Re: Notification of *Ex Parte* Presentation
LightSquared Subsidiary LLC, Application for Modification of
Authority for Ancillary Terrestrial Component
(File No. SAT-MOD-20101118-00239)
LightSquared Subsidiary, LLC, Technical Working Group Report
(IB Docket No. 11-109)

Precision GPS and Terrestrial MSS Broadband

Garmin Response to Latest LightSquared Proposal

General Location/Navigation GPS and Terrestrial MSS Broadband

Problems with Lower 10 MHz

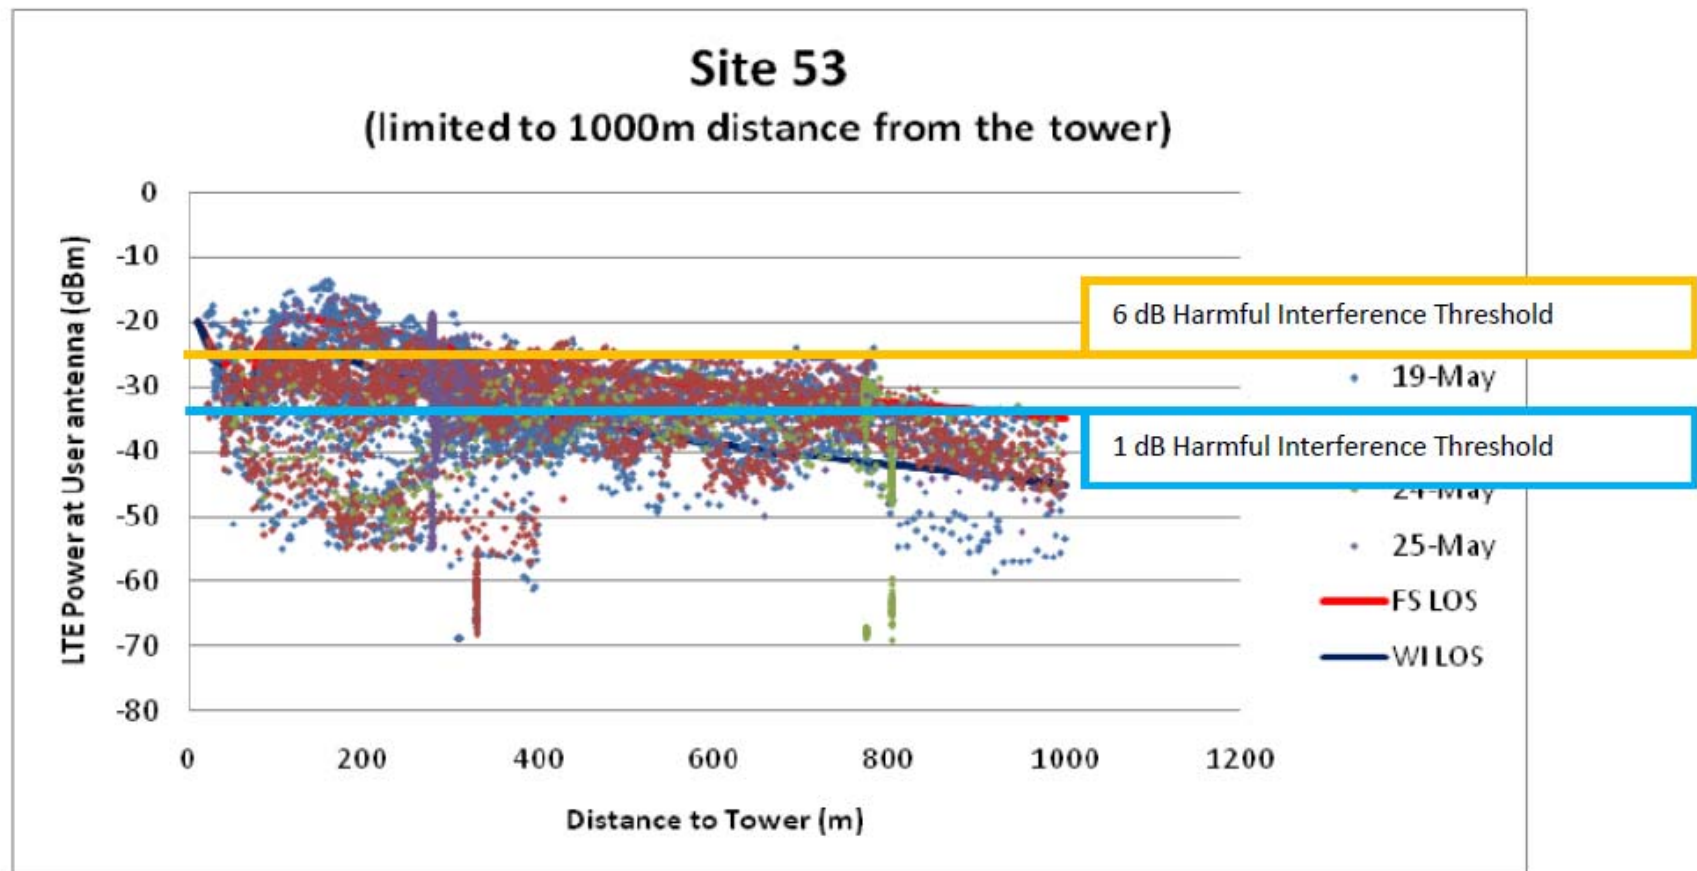
- Dispute over harmful interference: power level
 - TWG report shows all General Location/Navigation devices are free from harmful interference at LightSquared power levels of -33 dBm or less (1 dB of C/N_0 degradation)
 - LightSquared is using a power level of -25 dBm as a harmful interference threshold (6 dB of C/N_0 degradation)
- Real world testing in Las Vegas shows devices will experience power levels of -33 dBm and -25 dBm frequently at significant distances from the tower
- This is independent of which propagation model is used. The data stand by themselves.

Annotated Las Vegas “Live Sky” Results

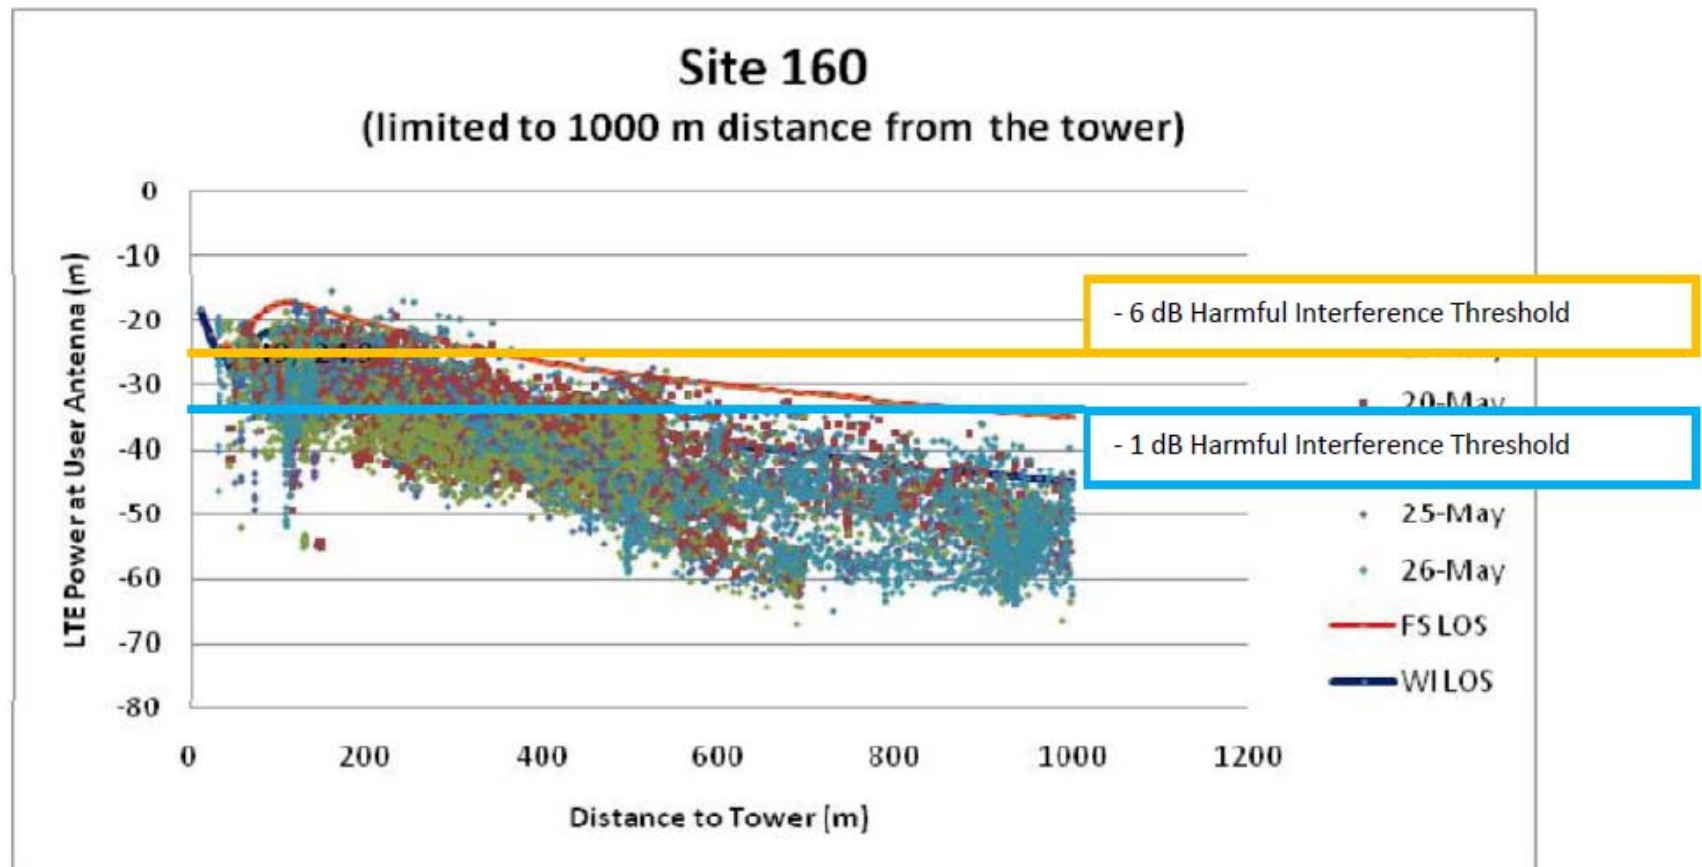
- Many points above interference threshold at large distances show that harmful interference *will* occur

Annotated Las Vegas “Live Sky” Results

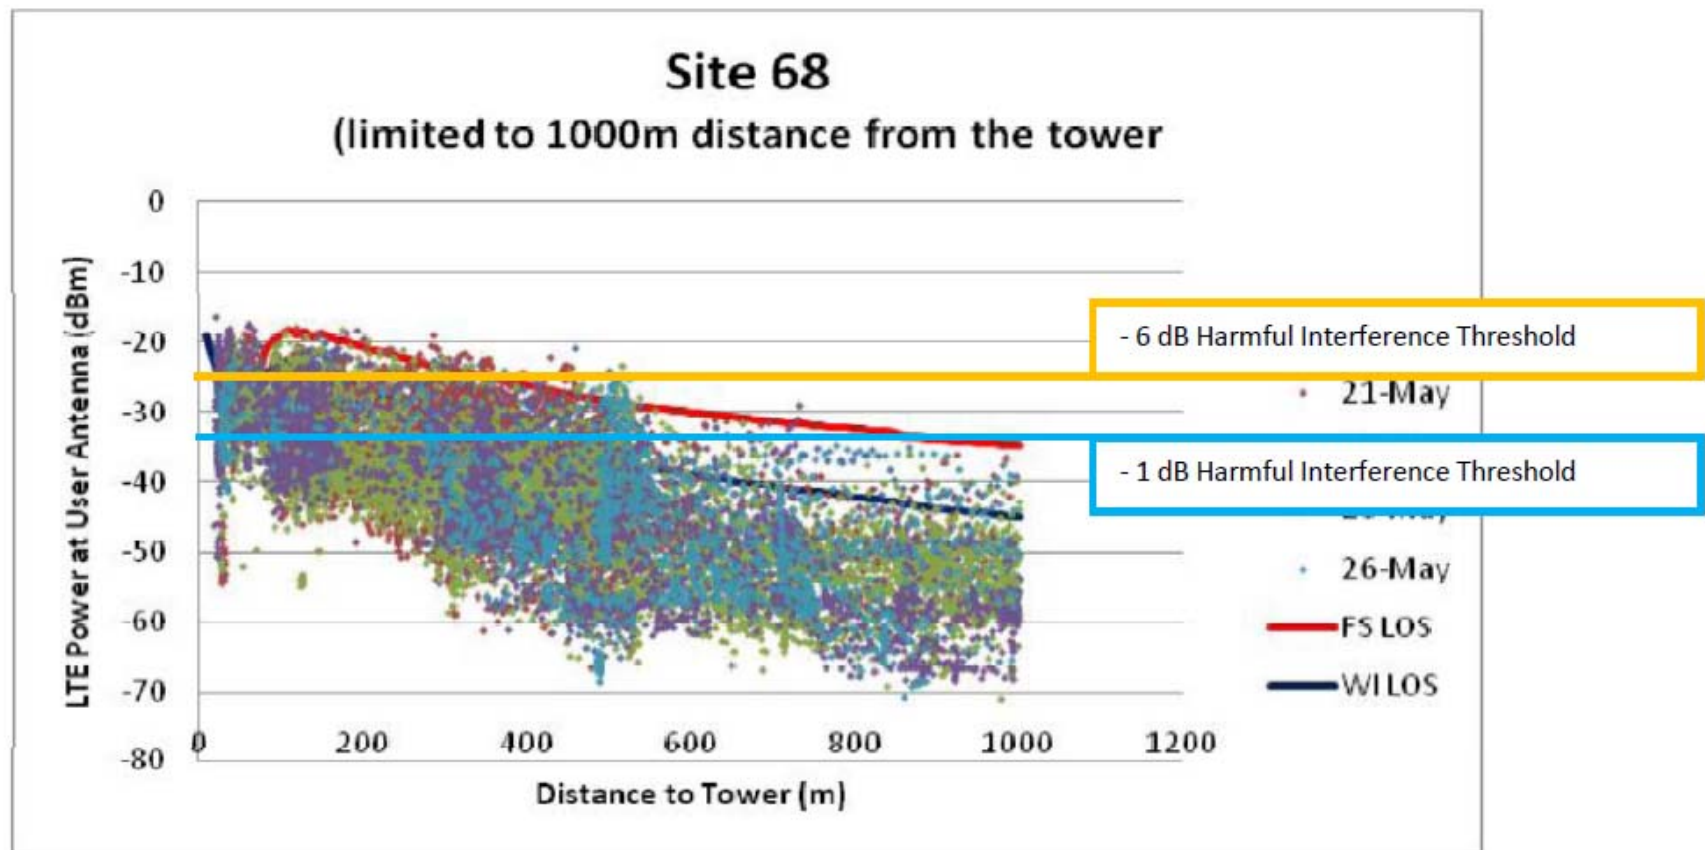
- Many points above interference threshold at large distances show that harmful interference *will* occur

RTCA/DO-229D Appendix C Figure C-1

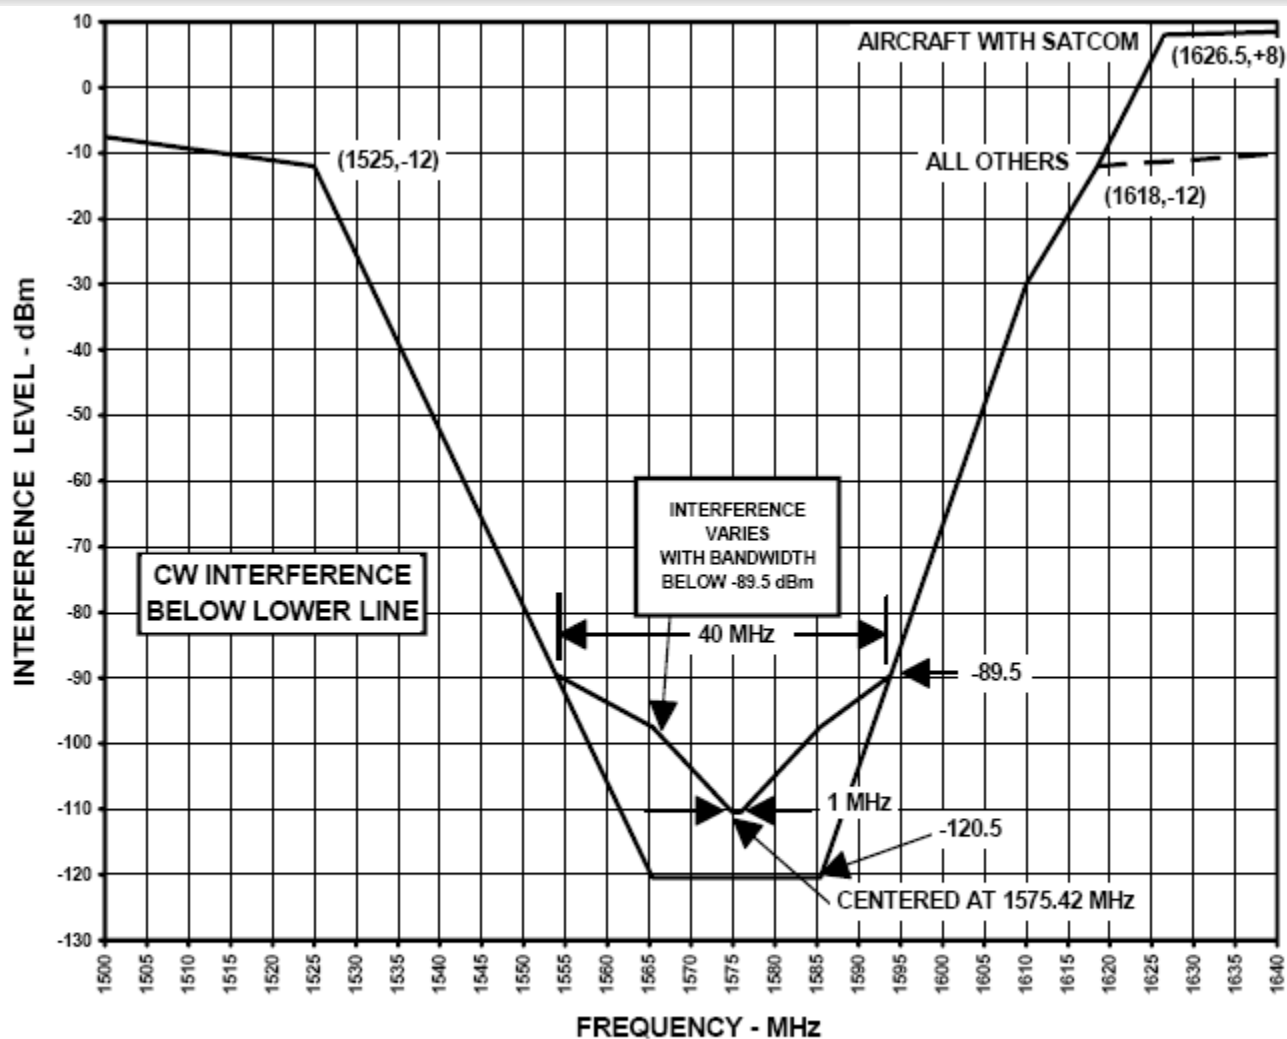
- RTCA/DO-229 Appendix C Figure C-1
 - Initial satellite acquisition is specified as requiring an additional 6 dB of margin
 - Numerous MOPS requirements are tested using interference conditions based on this mask
 - E.g., signal processing, initial acquisition, tracking, reacquisition, data decoding, Satellite-Based Augmentation System (SBAS) message loss rate, position integrity, and position accuracy
